NORTHEAST UTILITIES

Docket No. 50-423
AEC-MP3-308
BI0745

Millstone Nuclear Power Station, Unit No. 3:
Response to the Requests for Additional Information
that Resulted from the Acceptance Review

Responses to Enclosures 2 and 3

FIGURE 3.8-20
 FUEL TRANSFER TUBE
 MILLSTONE NUCLEAR POWER STATION
 UNIT 3
 FINAL SAFETY ANALYSIS REPORT

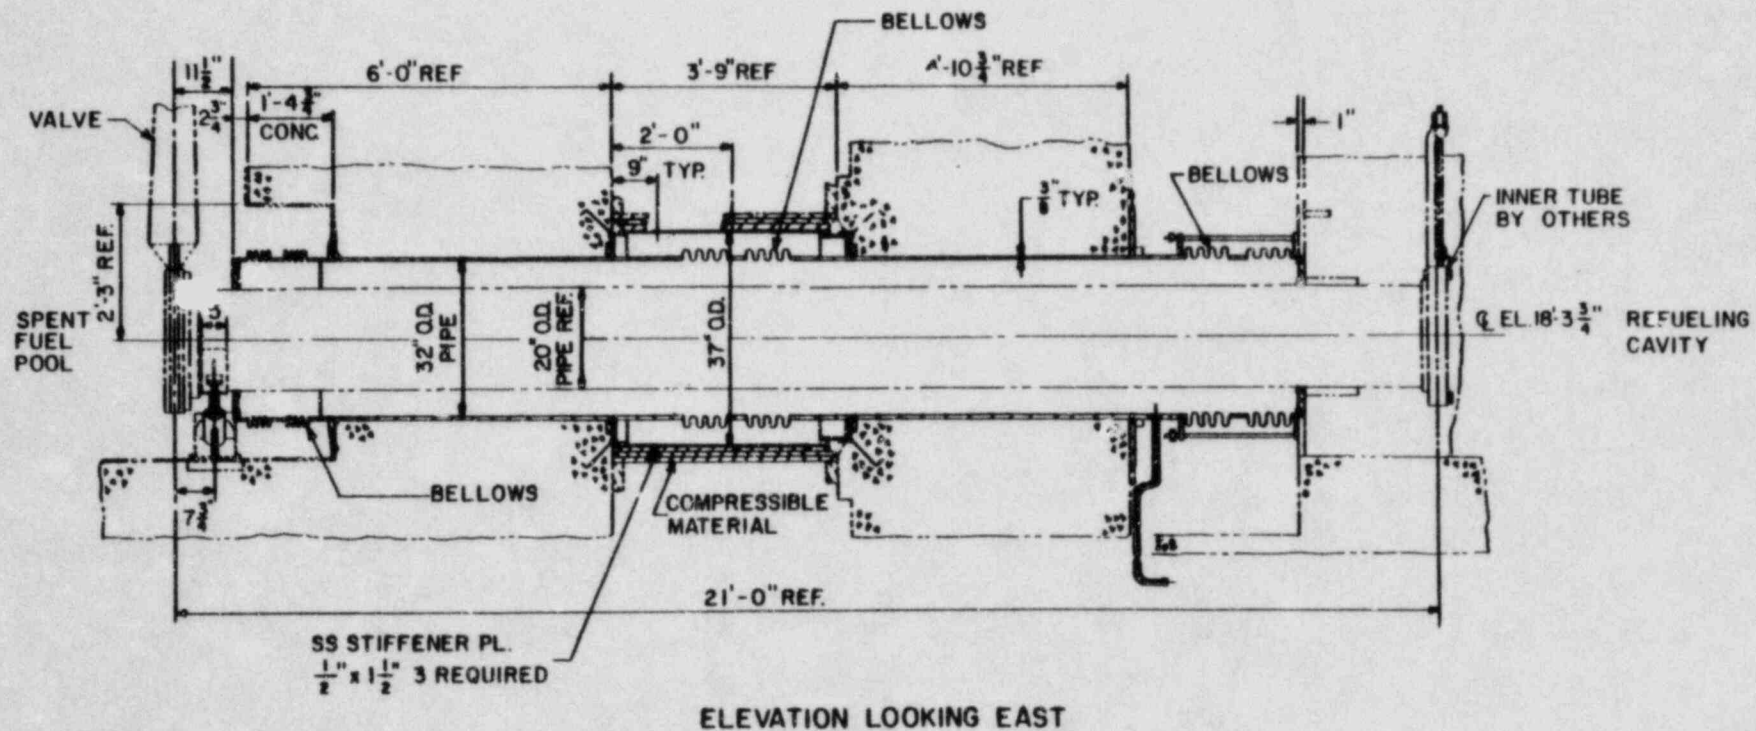
This section references Figure 3.8-20 that indicates it will be submitted later. Either provide this figure or state when it will be submitted.

Refer to Figure 3.8-20, Amendment 2.

FIGURE 5.4-6
RESIDUAL HEAT REMOVAL SYSTEM
PROCESS FLOW DIAGRAM
MILLSTONE NUCLEAR POWER STATION
UNIT 3
FINAL SAFETY ANALYSIS REPORT

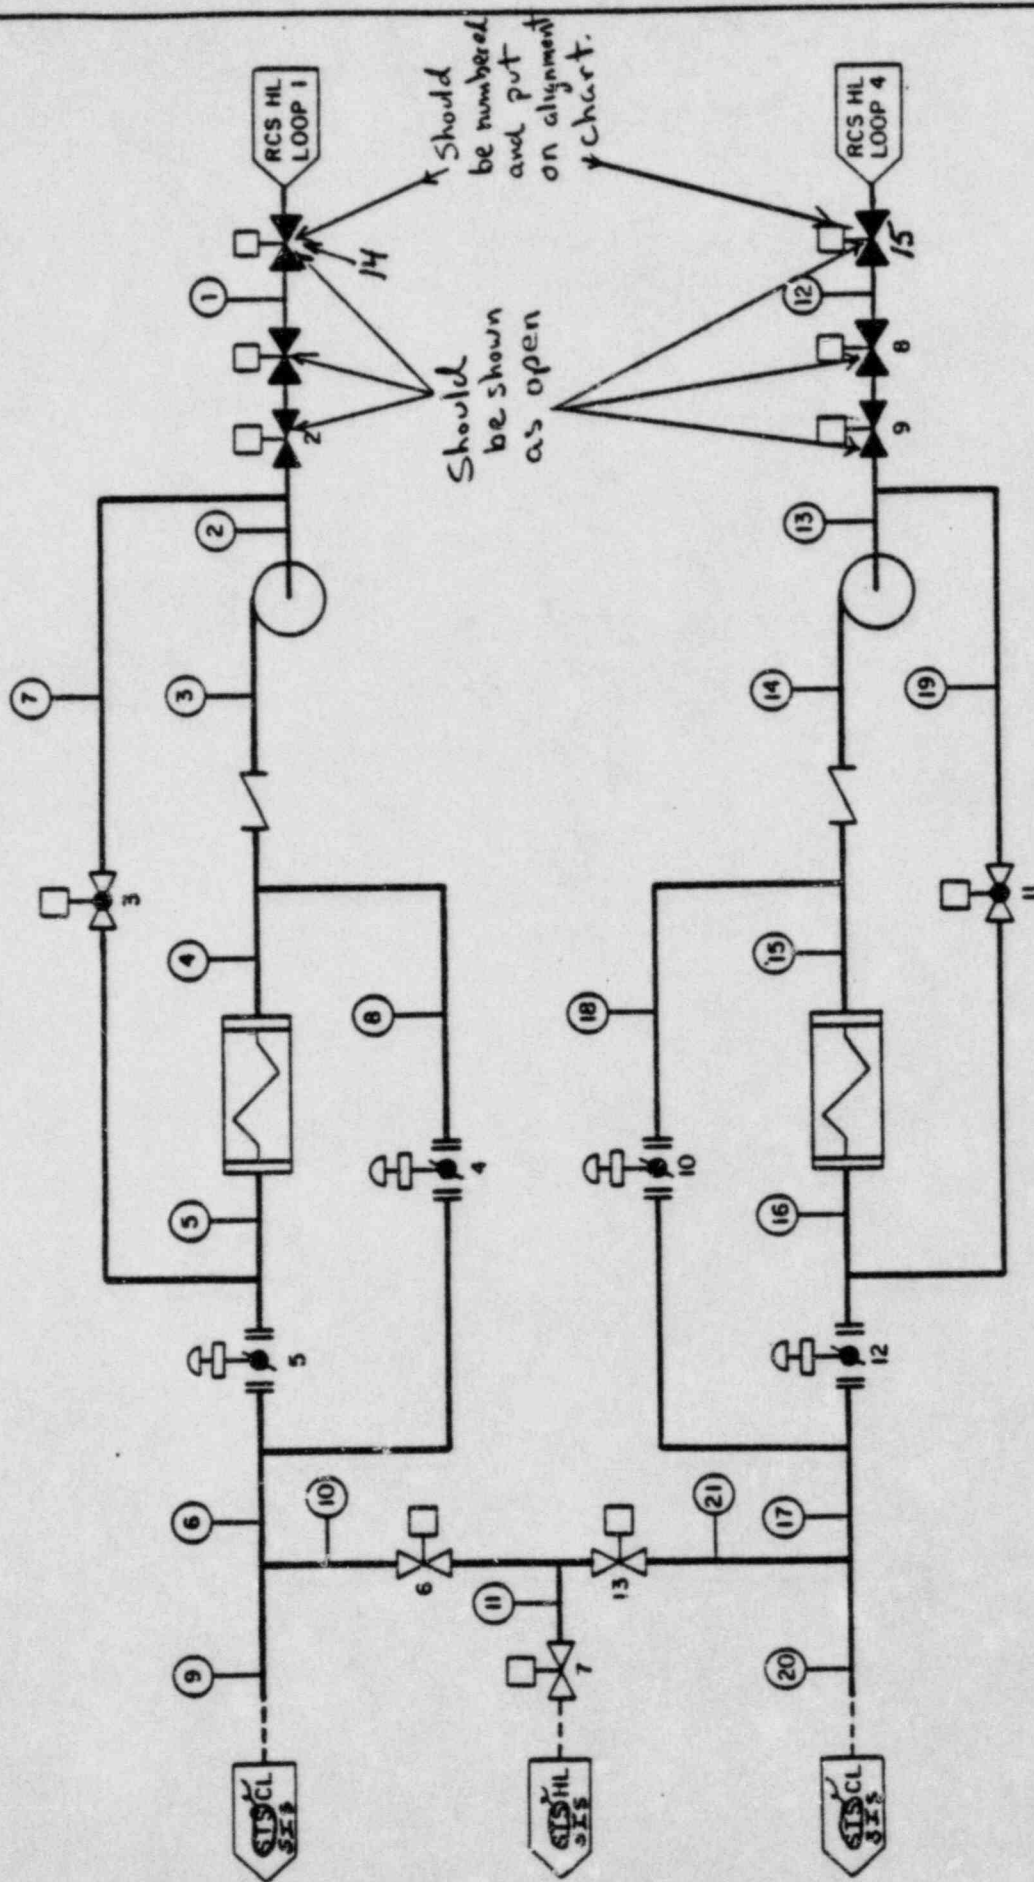
Section 5.4.7.2.1 refers to Figure 5.4-6. The notes for this figure appear to be incomplete in that the data for the process flow conditions are not presented. Provide the process flow conditions.

Revised notes to Figure 5.4-6 are provided in Amendment 2.
